re: Grading and Site Servicing Plan Review
Proposed Commercial Development
3700 Twin Falls Place, Block 2 – Ottawa, Ontario

file: PG7255-MEMO.01

Further to your request and authorization, Paterson Group (Paterson) prepared the current memorandum to provide a review, from a geotechnical perspective, of the grading and site servicing plans for the proposed commercial development to be located at the aforementioned site. This memorandum should be read in conjunction with the Geotechnical Investigation Report (Paterson Group Report PG7255-1 dated October 7, 2024.)

Figure 1 – Markup Site Servicing Plan for the Location of Pipes and Culverts Where Insulation Will Be Required.

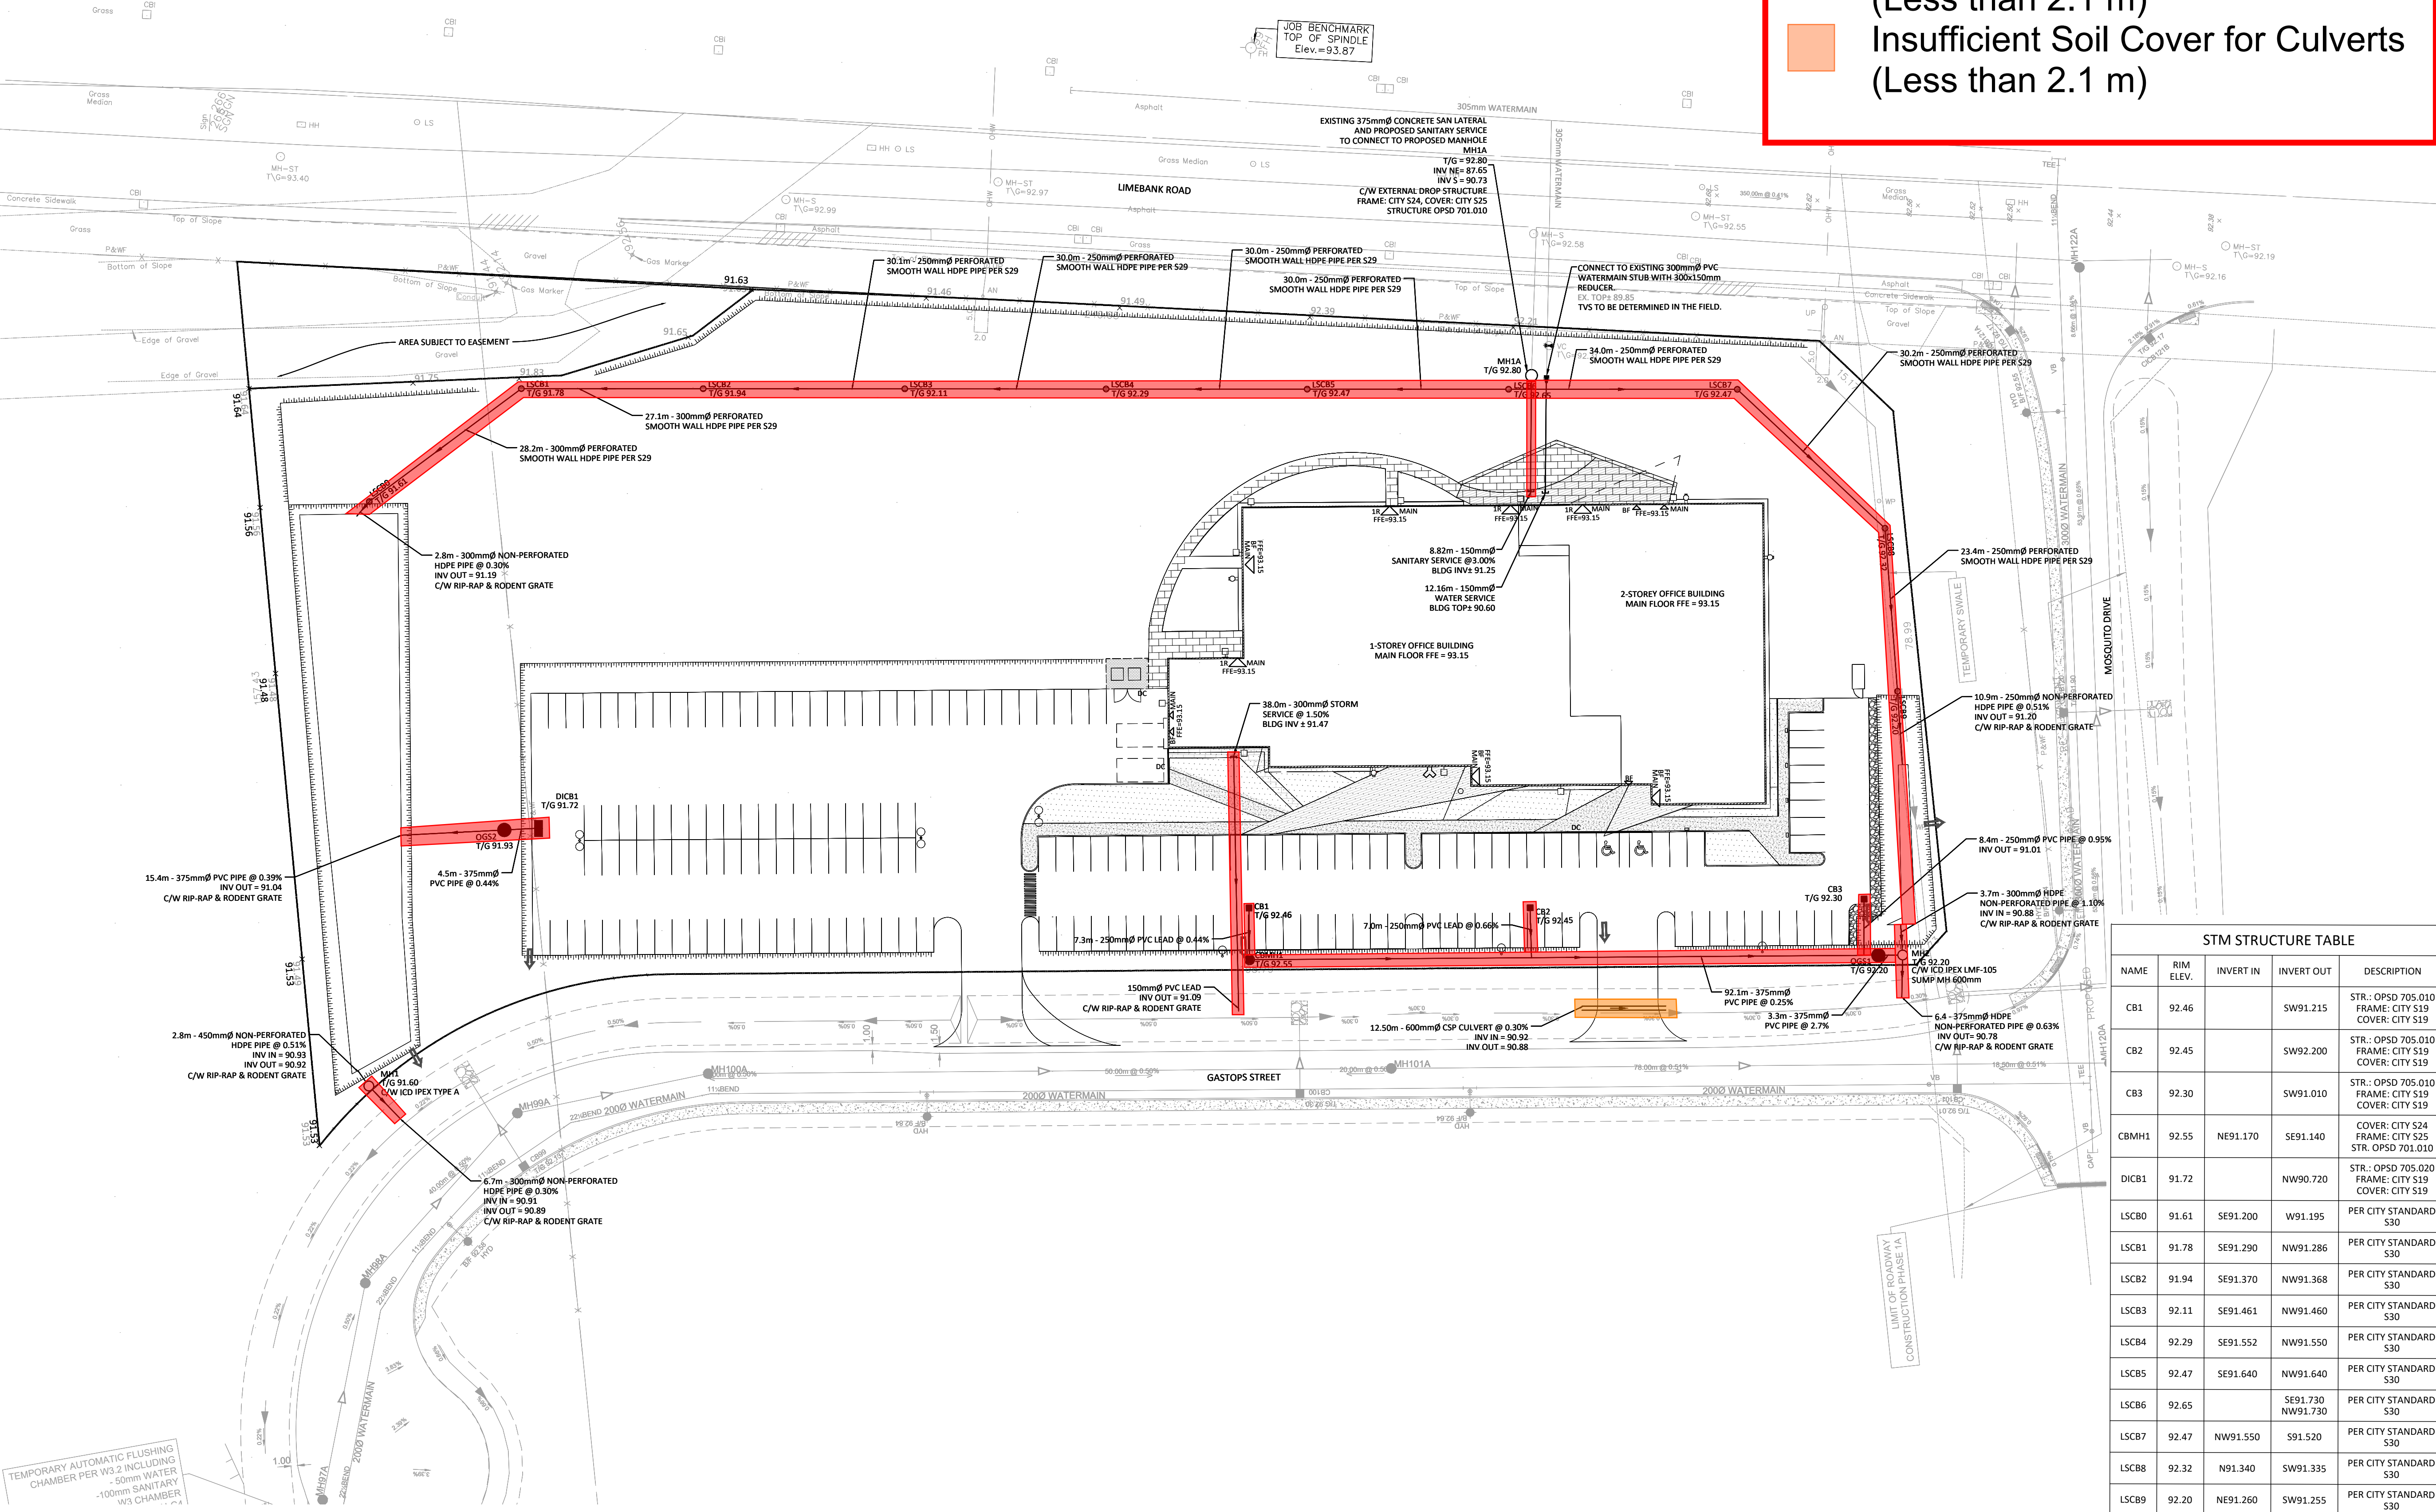
Based on our review of the above-noted site service plan, when assuming an approximate USF depth of 1.5 m, it should be noted that all services will be constructed outside the lateral zones of the proposed footings of the building and are considered to be acceptable from a geotechnical perspective. However, insufficient frost protection has been provided for the proposed storm and sanitary sewer pipes as well as the proposed culvert structures throughout the subject site. It should be noted that the elevation for the proposed connection to the existing watermain pipe was not available on the above-mentioned drawing. The watermain connection elevation should be reviewed by Paterson when available.

Reference should be made to Figure 1 – Markup Site Servicing Plan for the Location of Pipes and Culverts Where Insulation Will Be Required, attached to this memorandum.

It should be noted that the aforementioned storm and sanitary sewer pipes are located within the frost zone, which is 2.1 m below the finished grade. In the following section, frost protection of the site servicing is recommended where insufficient frost cover has been provided.

In addition, it should be noted that based on the invert elevation of the proposed culvert at the southwest side of the subject site and the proposed ground surface at this location, insufficient soil cover (less than 2.1 m) is provided for the culvert structure. Therefore, a minimum 75 mm thick layer of HI-40 rigid insulation or an approved equivalent should be placed directly above the native subgrade prior to the placement of the concrete culvert structure. The rigid insulation should extend a minimum of 600 mm horizontally beyond the edge of the culvert on all sides. The insulation should be placed flat and level over the subgrade with no gaps between sheets. The insulation placement should be reviewed in the field by Paterson at the time of placement.

Any portion of the services installed at a depth of 2.1 m below the finished grade or deeper are considered to have sufficient soil cover for frost protection. Where insufficient soil cover is present above the invert of storm and sanitary sewer pipes, the following frost protection criteria should be followed:

Thermal Condition	Soil Cover Provided (mm)	Insulation Dimensions	
		Thickness (mm)	Extension (mm)
Unheated	1800 to 2100	25	Extend 300 mm horizontally beyond the outer edge of the pipe
	1500 to 1800	50	Extend 600 mm horizontally beyond the outer edge of the pipe
	1200 to 1500	75	Extend 900 mm horizontally beyond the outer edge of the pipe
	900 to 1200	100	Extend 1200 mm horizontally beyond the outer edge of the pipe
	600 to 900	125	Extend 1200 mm horizontally beyond the outer edge of the pipe
	300 to 600	150	Extend 1500 mm horizontally beyond the outer edge of the pipe

Typical Frost Insulation Detail for Servicing Pipes

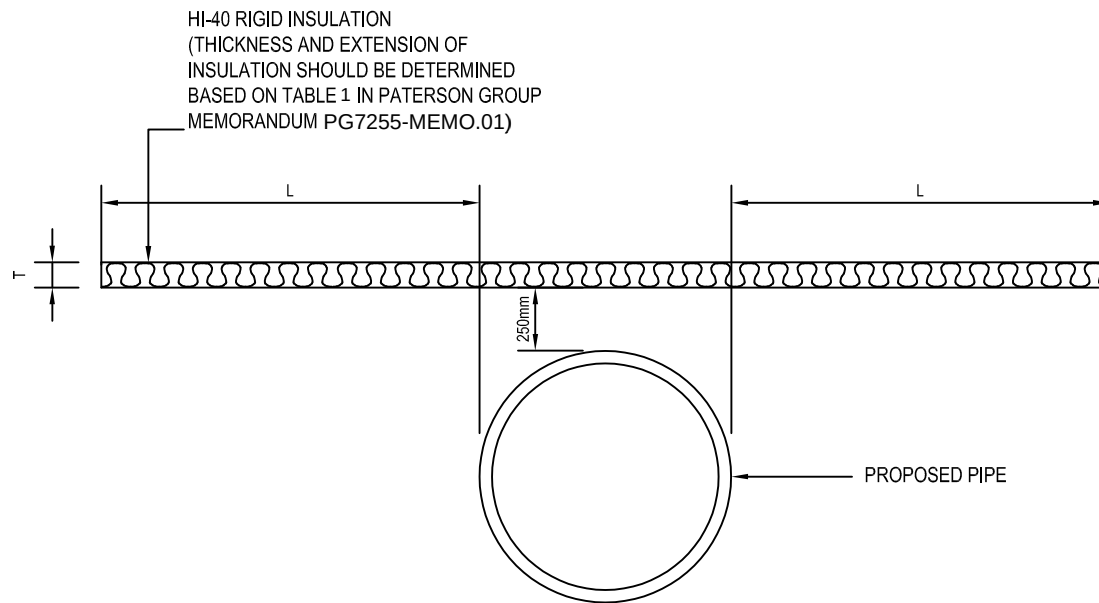
All rigid insulation should consist of either Dow Chemical High-Load 40 (HI-40), Styro Rail SR.P400, or equivalent approved by Paterson. The placement of all insulation within the service trenches must be reviewed and approved by Paterson personnel at the time of construction. Reference should be made to Figure 2 – Typical Frost Insulation Detail, attached to this memorandum.
